HISTORIC LANDMARK COMMISSION
APPLICATION FOR A CERTIFICATE OF APPROPRIATENESS
AUGUST 3, 2022
HR-2022-105301
CASTLE HILL HISTORIC DISTRICT
1124/1122-1126 W. 6TH STREET

PROPOSAL

Deconstruct the building, reconstruct the façade, and construct a new multi-story mixed-use building beyond.

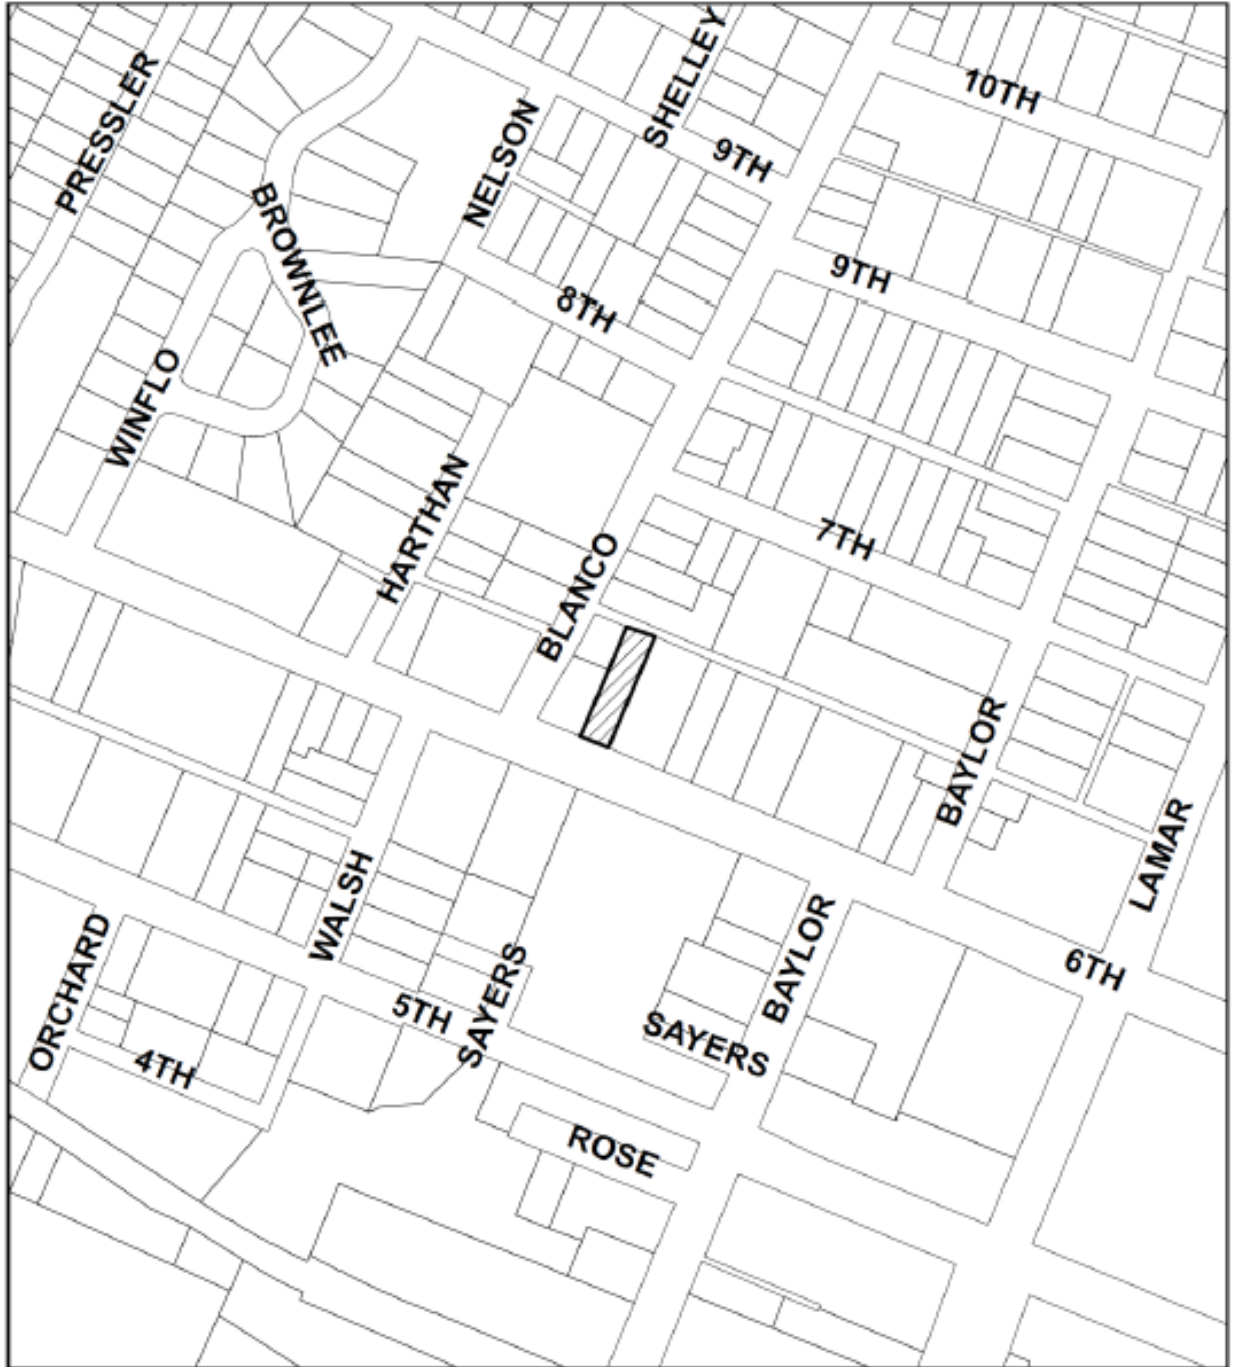
(a) Repair, rather than replace, original materials. Replace only materials that are deteriorated beyond repair or that detract from and are not original to the building. Replacement materials shall match the original materials when feasible.
 The proposed project entirely deconstructs the existing building, leaving the façade only. It replaces character-defining divided transoms with undivided fixed glazing and replaces the terra cotta roof with another material.

The proposed project replicates the first floor and existing roofline at a new second story.

The proposed project appropriately reconstructs the existing façade, except for the glazing and roofline.

See A.1(a). The proposed addition is constructed immediately atop the reconstructed façade.

See D.1(a). The proposed second floor is not set back, effectively creating a new two-story pedestrian-level façade. The

The proposed second-floor wall materials appear compatible with the existing wood siding. Though the brick and glazing at upper floors are less compatible, their stepped-back position appears to minimize some visual weight. The proposed roof material does not appear to match the existing terra-cotta.

The proposed project replicates the first-floor roof pitch at the second floor. The compound flat roof forms at the upper stories does not comply with this standard.

The proposed second-floor window pattern is compatible, but not differentiated from the historic-aged windows at the first floor. Their undivided fixed glazing is not compatible. The blind walls facing the street at the upper stories are not compatible.

Set the second floor back from the reconstructed façade. Do not exactly replicate existing openings at second floor.

Refer the project to the Architectural Review Committee for further feedback. The proposed project renders a contributing building noncontributing, though the design appears to take some cues from the historic structure.
